United Costume Limited R.N. Knit Tex Ltd.

Malancha Nagar, I/A, R # 02, West Isdair, Fatullah, Narayanganj
(23.633561N, 90.481962E)

7th January 2019

Observations

Column Layout

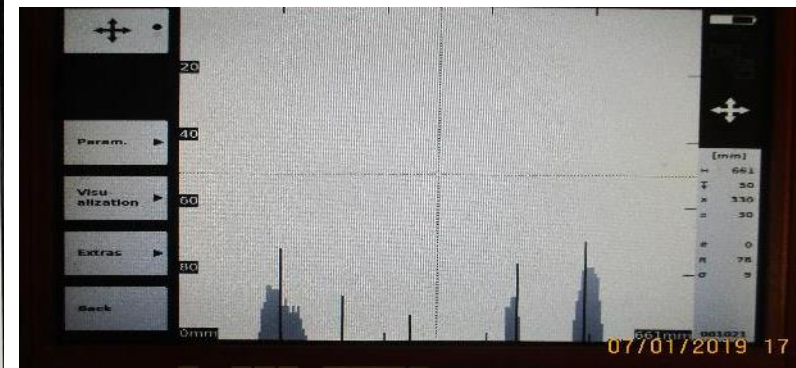
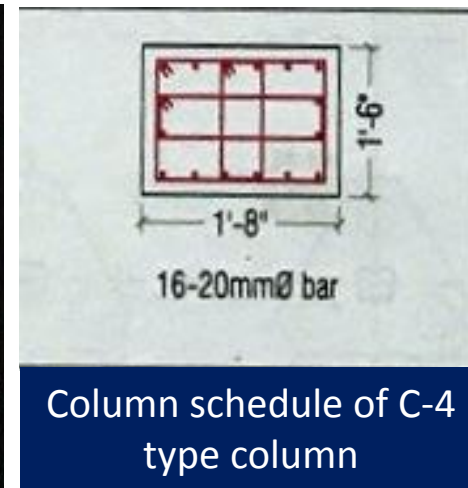
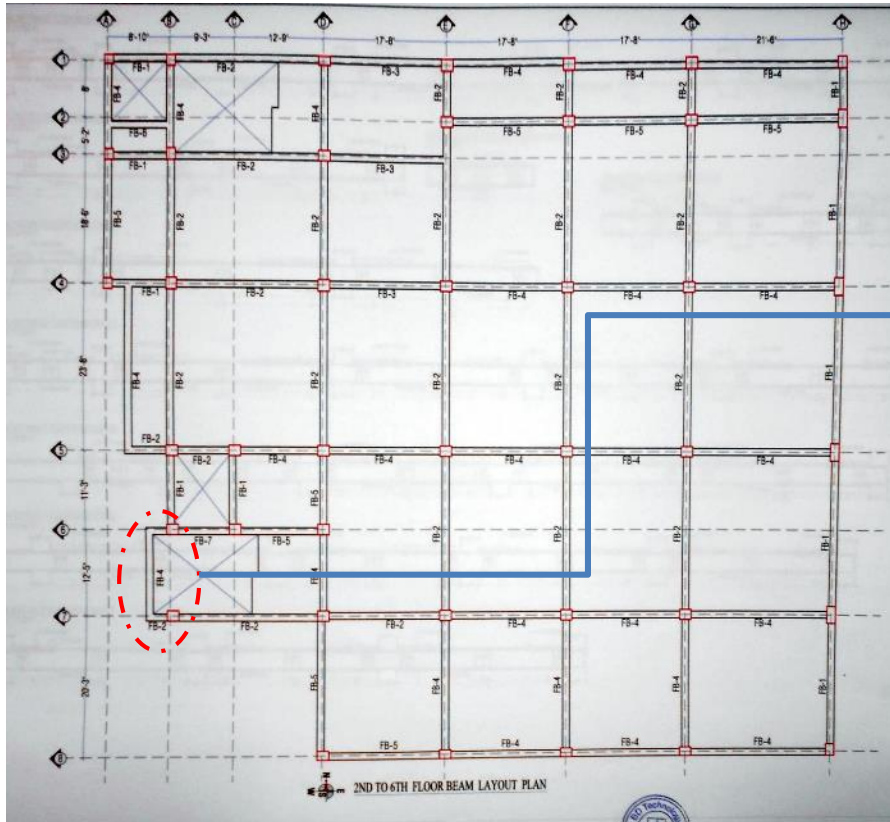
The number of rebar of C-4 column was found 5 number in 1'-8" face instead of 6 number as shown in the as-built drawing. The rebar number of the column is required to be confirmed in column schedule and layout.

On the marked location in typical beam layout, no beam was found in any floor except ground floor whereas the beam was shown in as-built drawing.

Missing beam in all floor

Beam is found on Ground floor only
